# Site Accessibility Evaluation

## Storage Building

719 S Capitol St  
Longfellow, IA 52240

ADA Only

### Finding: 3

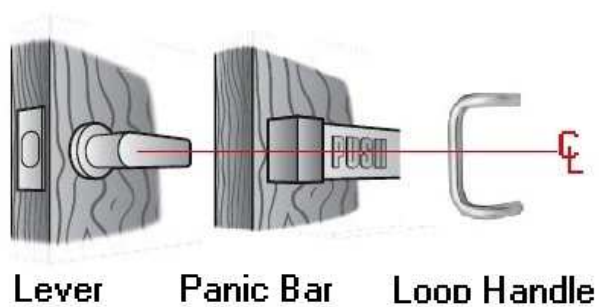
The door operating hardware is not accessible.

W RR - knob

Replace hardware with lever hardware or hardware operable without a tight pinch or grasp

Operating hardware must be centered between 34" and 48" above the floor or ground

### Finding: 8

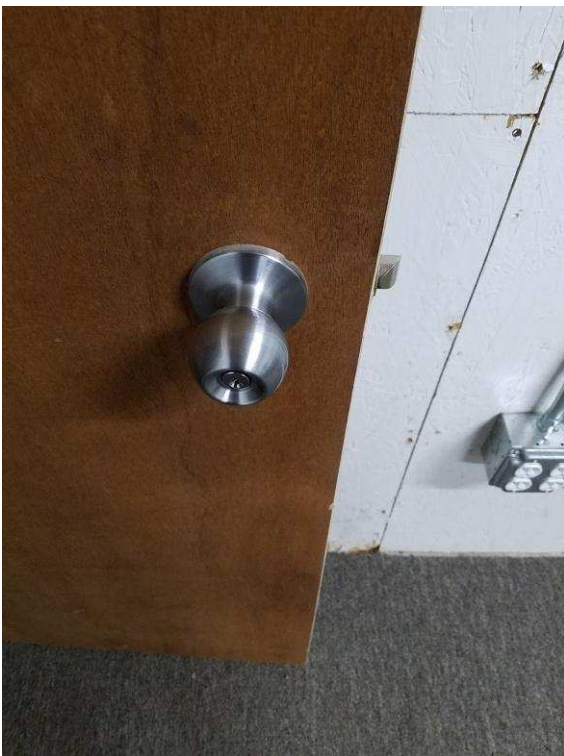
Stairwell - stairs on push, knob

Leave as is lack of maneuvering clearance due to stairs, infeasible to correct

Replace hardware with lever hardware or hardware operable without a tight pinch or grasp

### Finding: 9

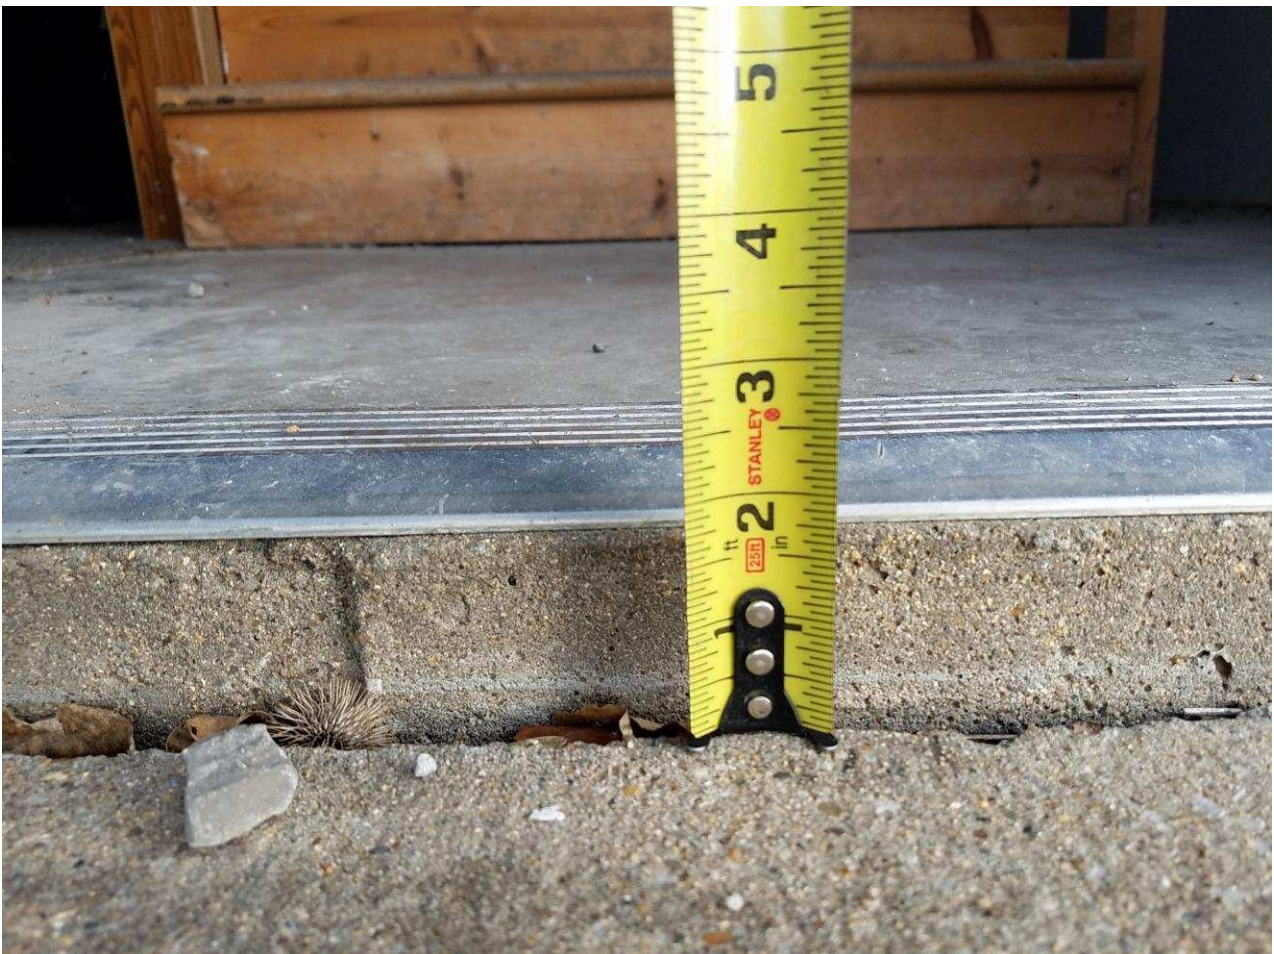
Stair exit - 2" CIL,  
small pad

For all doors along the public circulation route, provide required maneuvering clearance on push and pull side of doors

### Finding: 10

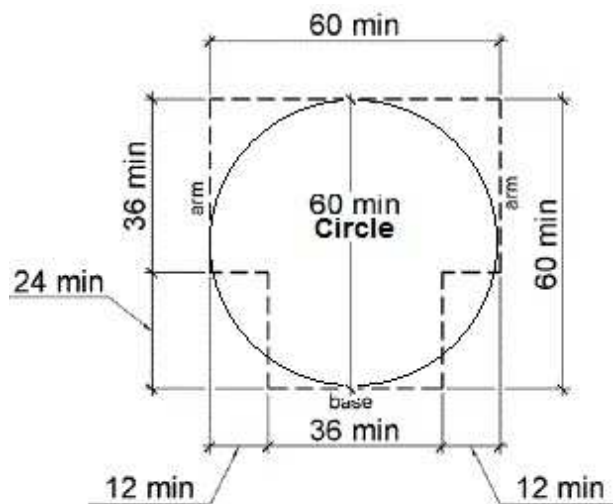
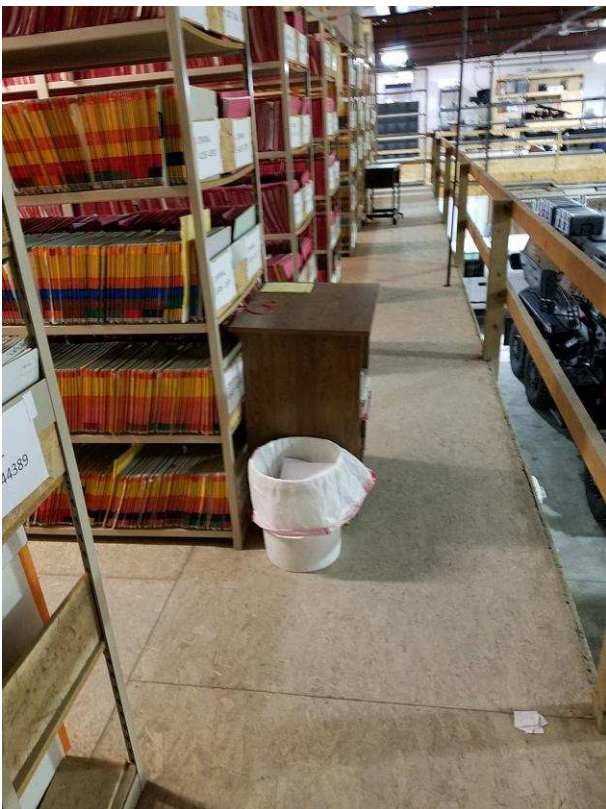
There is insufficient turning space within this room or space.

mezzanine lacks AR and turning

For deficit, leave as is, employee work area pursuant to 2010 Standards 106.5 Defined Terms, until an employee with a disability works here

### Finding: 11

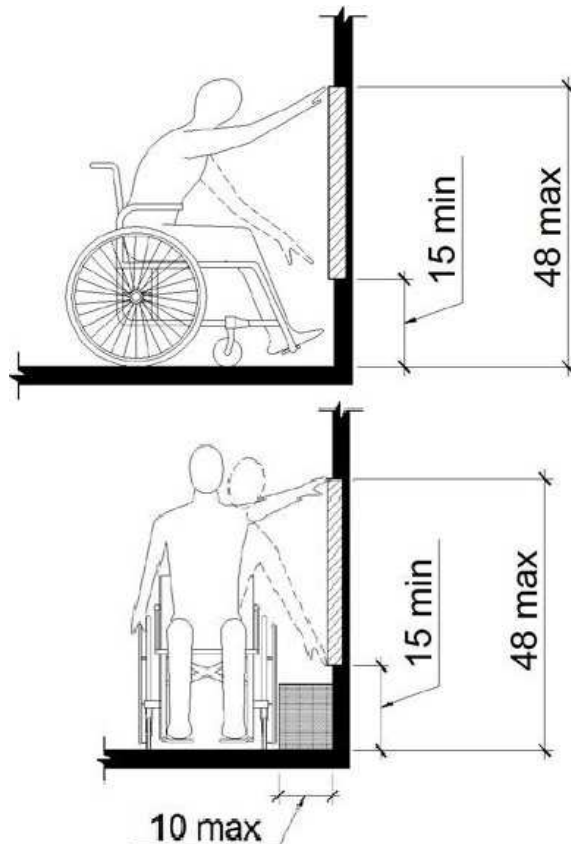
The keybox is positioned too high for either a side or front approach.

main garage- keybox  
72"

For deficit, leave as is, employee work area pursuant to 2010 Standards 106.5 Defined Terms, until an employee with a disability works here

### Finding: 13

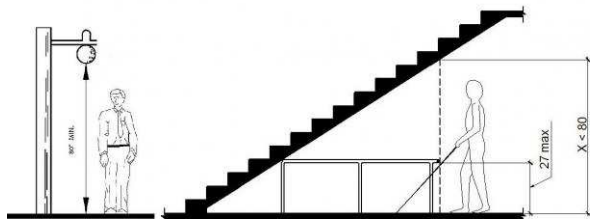
The shelves project more than 4 inches into the circulation path.

garage- shelves

For deficit, leave as is, employee work area pursuant to 2010 Standards 106.5 Defined Terms, until an employee with a disability works here

### Finding: 14

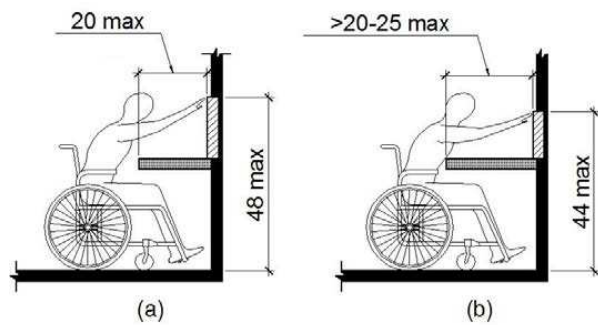
The controls are located such that operation require reaching across burners.

kitchen- oven  
controls on back  
panel

Replace oven with one having controls on the front panel

Finding: 15

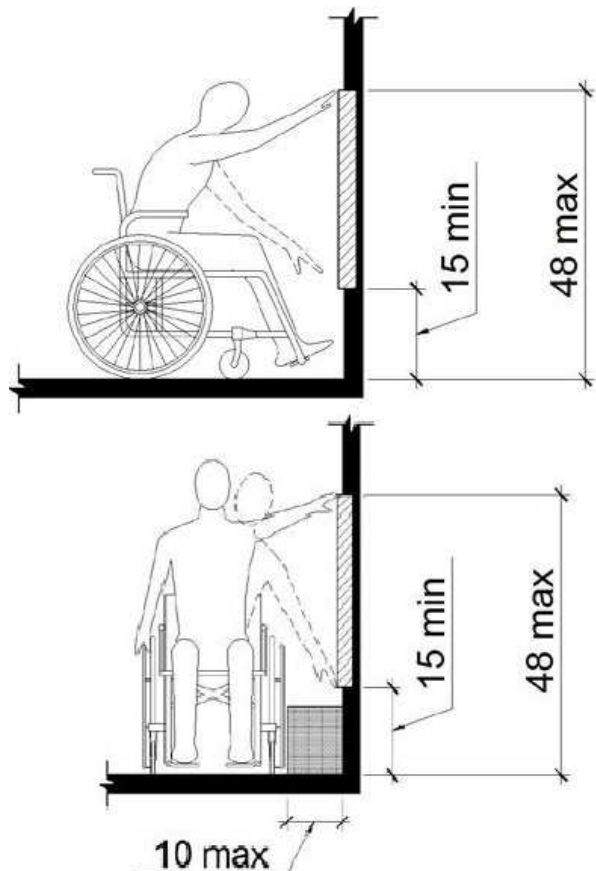
The microwave is positioned too high for either a side or front approach.

kitchen- 67"  
microwave

Remount operable parts to be in reach range of 15" min to 48" max

### Finding: 16

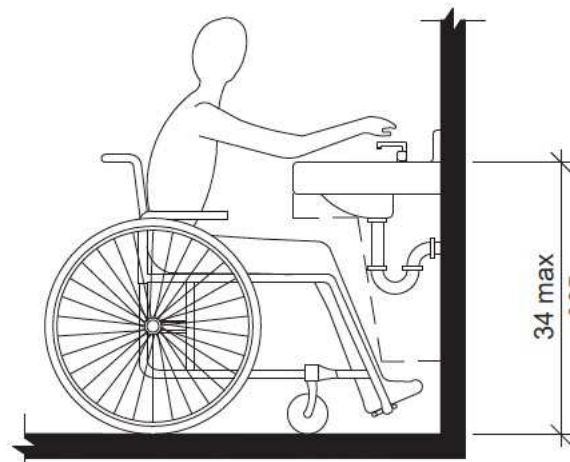
The sink is not accessible.

kitchen- 36" rim and  
lacks knee clearance

Lower sinks to max 34" aff to front of rim

### Finding: 17

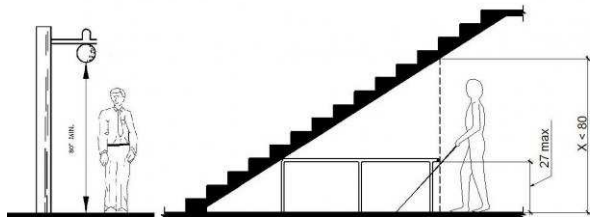
The cabinets projects more than 4 inches into the circulation path.

kitchen- 2 sets of cabinets

Relocate protruding objects or place cane detectable warning or bollard at foot of item

### Finding: 18

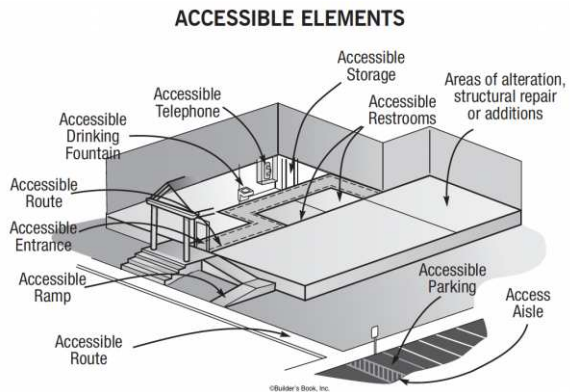
There is no accessible route to the mezzanine

stairs to mezzanine-  
only access up; stairs  
to larger mezzanine,  
no other route

Stairs only to upper level storage, leave as is, employee area only; reassign duties if an employee with a disability requires access here

### Finding: 19

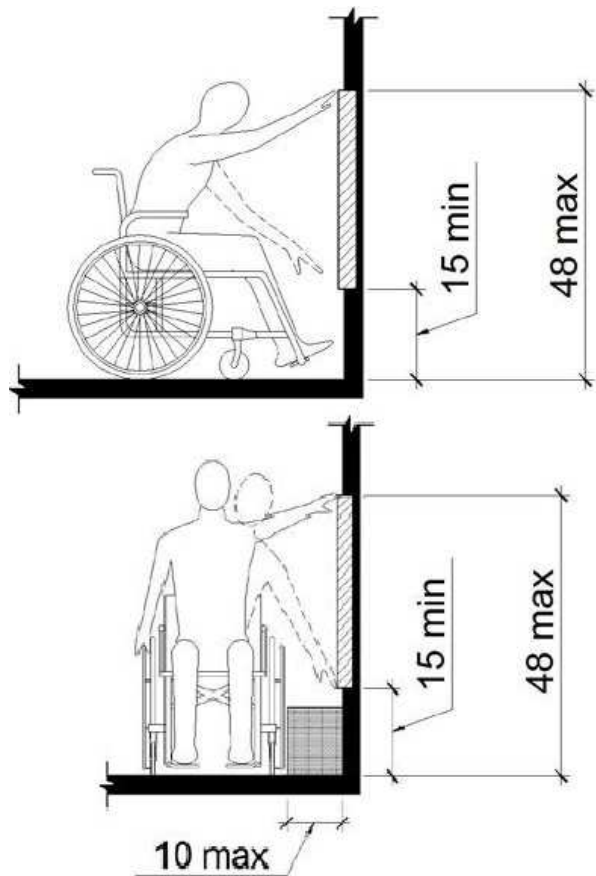
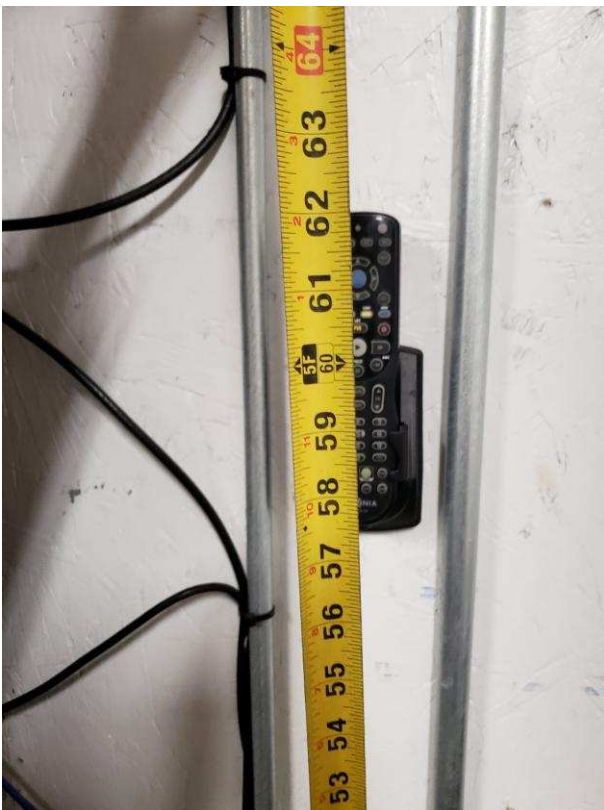
The TV remote is positioned too high for either a side or front approach.

lounge- tv remote

Remount operable parts to be in reach range of 15" min to 48" max

### Finding: 20

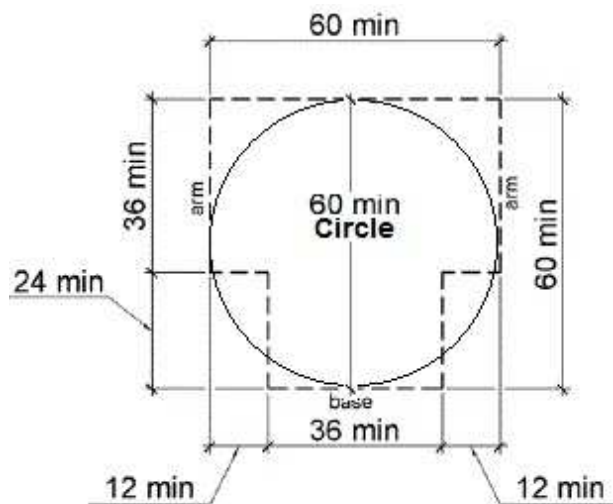
There is insufficient turning space within this room or space.

storage in lounge-furniture

For deficit, leave as is, employee work area pursuant to 2010 Standards 106.5 Defined Terms, until an employee with a disability works here

### Finding: 21

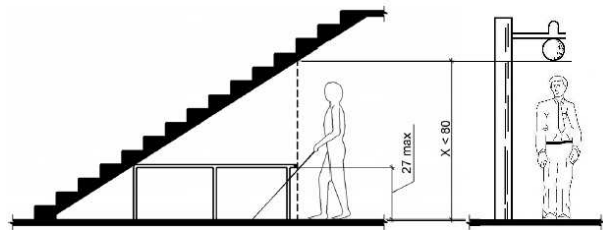
The stairway extends down too close to the route of travel.

storage in lounge-  
stairs low

For deficit, leave as is, employee work area pursuant to 2010 Standards 106.5 Defined Terms, until an employee with a disability works here
